# Makasiiniranta quality and concept competition

Instructions for further planning 2022

# INSTRUCTIONS AND GUIDELINES FOR FURTHER PLANNING

24.11.2022

Street section of Laivasillankatu street

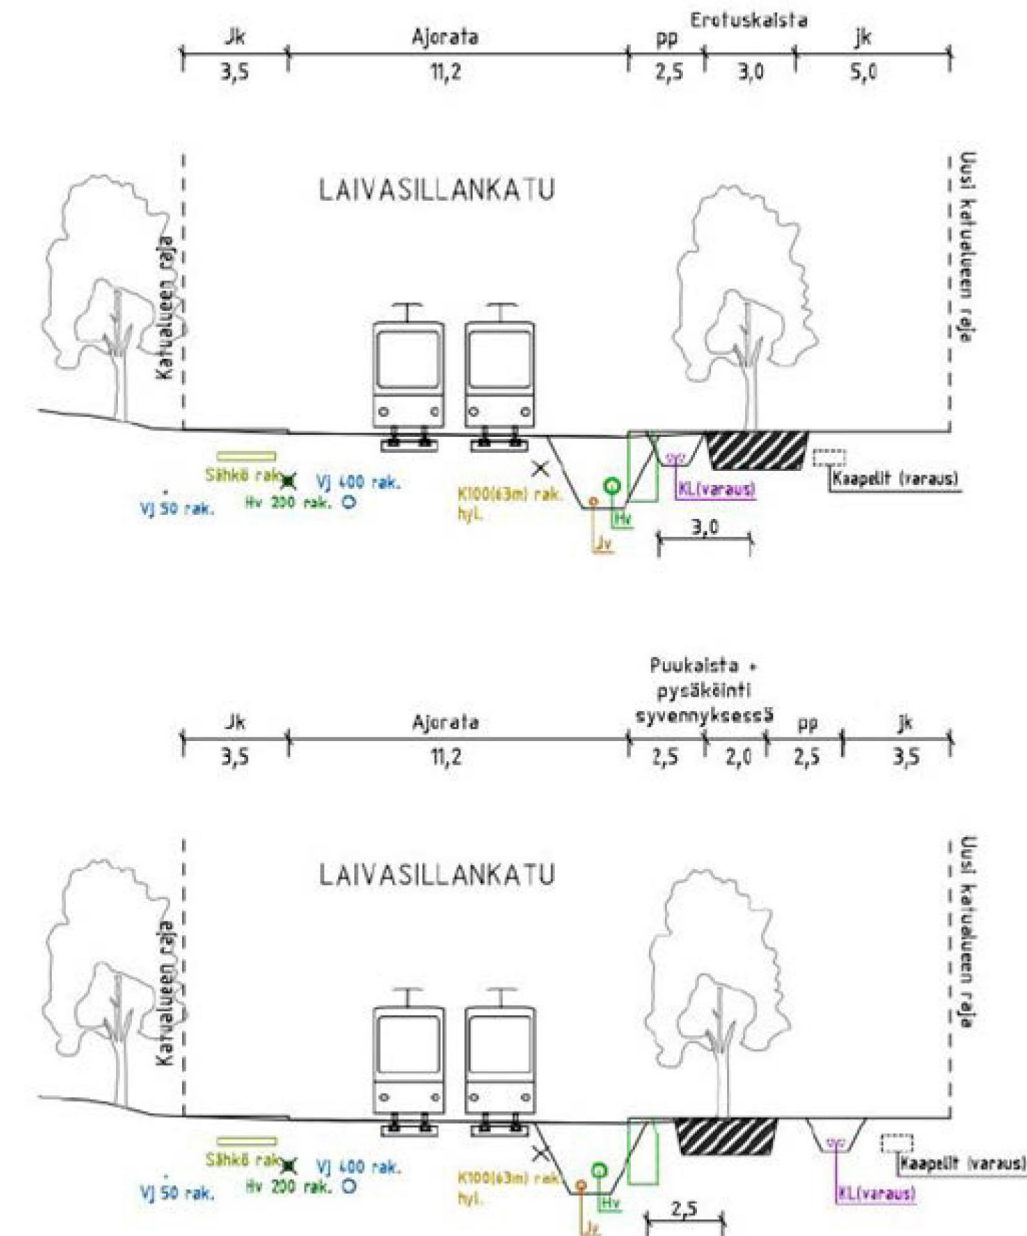
The feasibility of the streetscape presented for Laivasillankatu street must be examined during further planning. In particular, the distance requirements for the existing municipal infrastructure as well as the line of trees presented along the street and required space allocations must be considered.

Below are the Laivasillankatu street sections showing the possible location for trees (Tähtitorninvuori on the left and Makasiiniranta on right).
